MCPB  
1/27/05  
Item # 8

**MEMORANDUM**

**REVIEW TYPE:** Site Plan Review  
**APPLYING FOR:** Approval of 73 townhouses on 6.32 acres, that includes 10 MPDUs on site  
**PROJECT NAME:** Fairland View  
**CASE #:** 8-05007  
**REVIEW BASIS:** Sec. 59-D-3, Zoning Ordinance: Site Plan required in the R-60 Zone under the MPDU Option

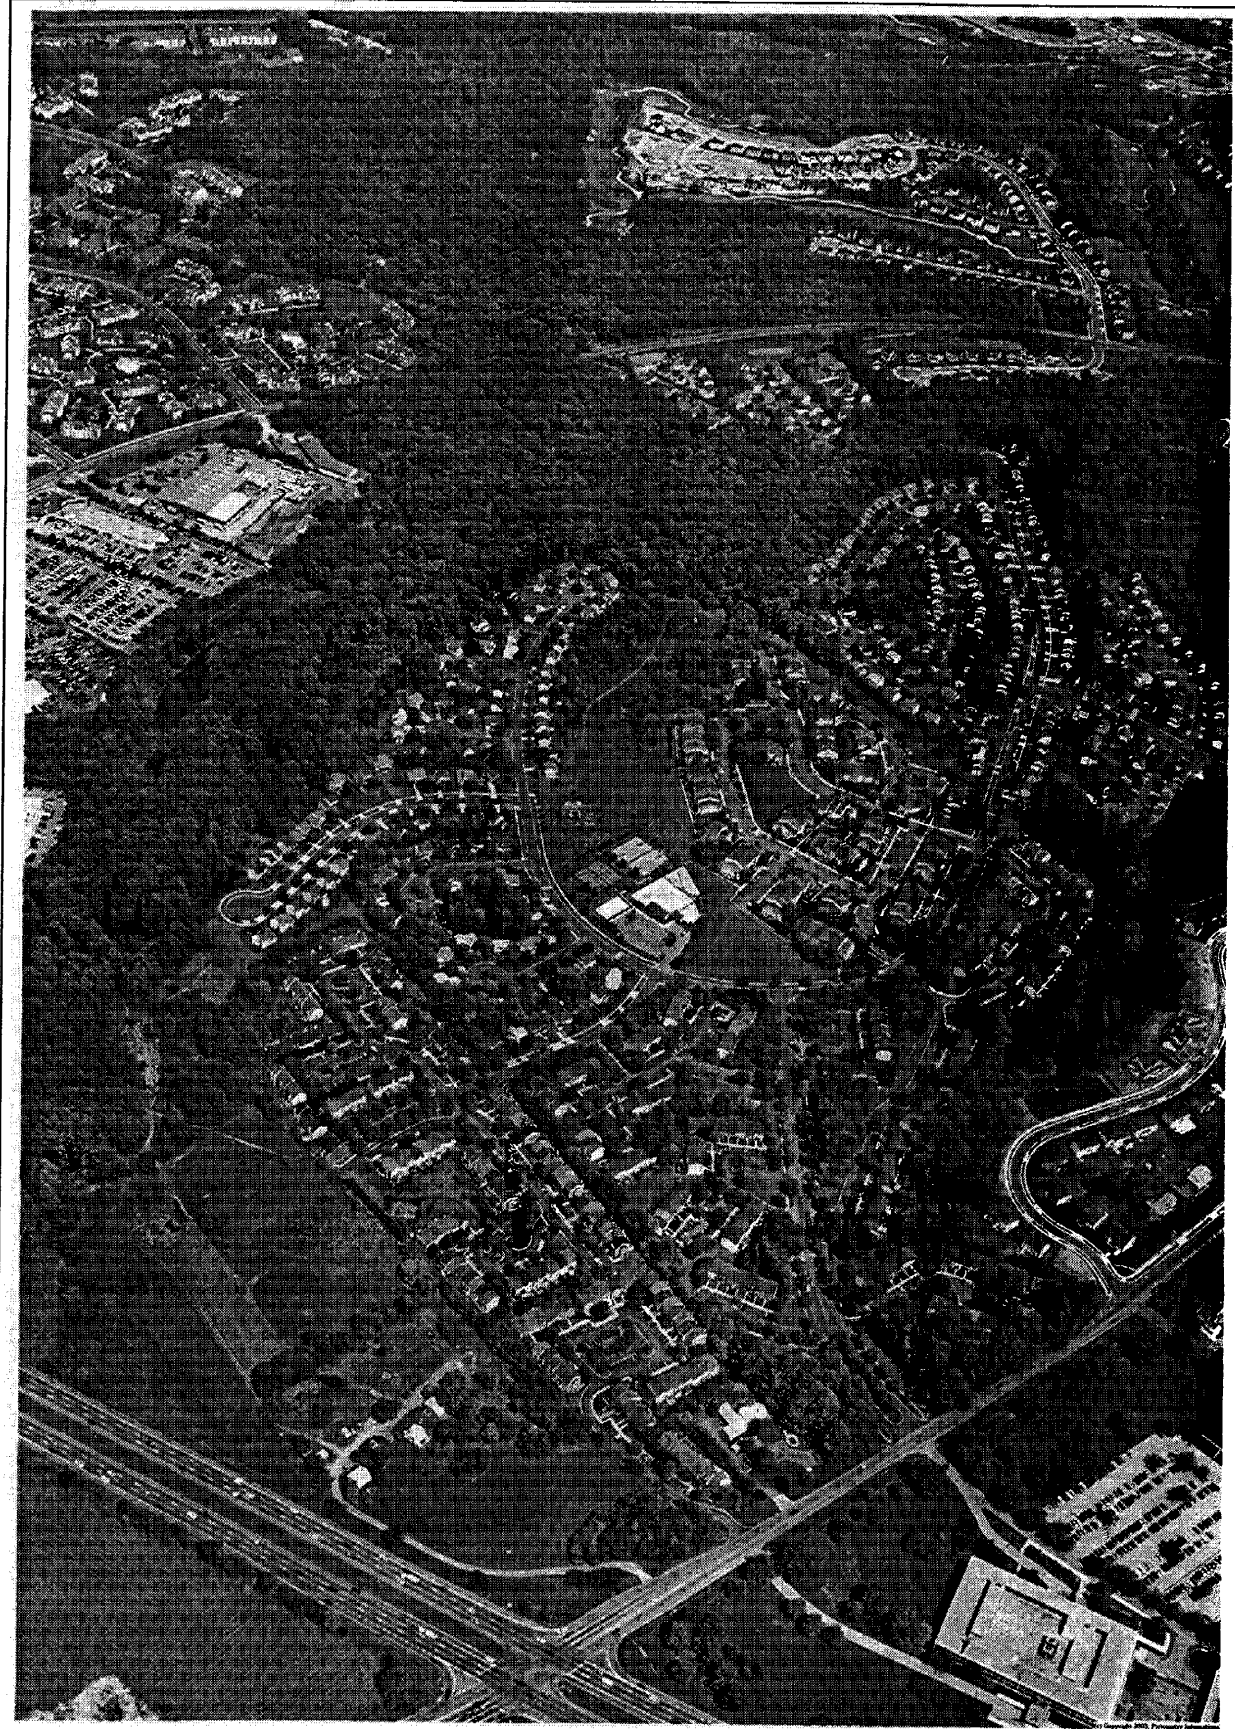
Through the Maryland State planning process known as *The Alternatives Retained for Detailed Study (ARDS)*, two feasible alternative road alignments have emerged, namely Corridor 1 and Corridor 2. The first follows a more southerly alignment incorporated within existing ICC Master Plans. The second offers a more northerly alignment not represented within any master plan proposal. Corridor 1 and its resultant interchange at Columbia Pike (US 29) would physically impact the proposed Fairland View development as shown on Attachment 1, based on contemporary information offered by SHA.

At the time of the Planning Board's consideration of the Preliminary Plan in October 2004, the state planning process (ARDS), in compliance with NEPA, provided for the Environmental Impact Study (EIS) that incorporates the two alternative alignments for the ICC (as relevant to the Fairland View site). As such, SHA had not issued a Declaration of Decision regarding the final alignment of the ICC, pending the final decision for the alignment, due by June 2005. The currently operational drawing, delineating the southerly alignment

(Corridor 1), was issued by SHA on March 17, 2004, Plat No. 56320 [See *Attachment 1*]. Considerations of the Preliminary Plan approval and current staff positions are outlined below:

**Subdivision Staff Position:** Subdivision staff acknowledged the applicant's desire and right to proceed with a Planning Board hearing for the site development plan. Staff presented a condition of approval that required the applicant to place in reservation the area delineated in the SHA drawing dated March 17, 2004, also recognized as Corridor 1.

**The Planning Board:** The Planning Board, at its hearing of October 28, 2004, took appropriate action, and approved staff the conditions as recommended with respect to the concurrent EIS and ARDS, thus requiring the reservation of the area of Corridor 1 until the earlier of September 1, 2005 or the Final Record of Decision is issued by the Federal Highway Administration. The applicant is further required to submit a Site Plan (or Site Plan Amendment) that respects the final reservation area.

**Site Plan Staff Position:** Site Plan staff incorporates the Planning Board's conditions of approval for the Preliminary Plan into the conditions of approval for Site Plan 8-05007.
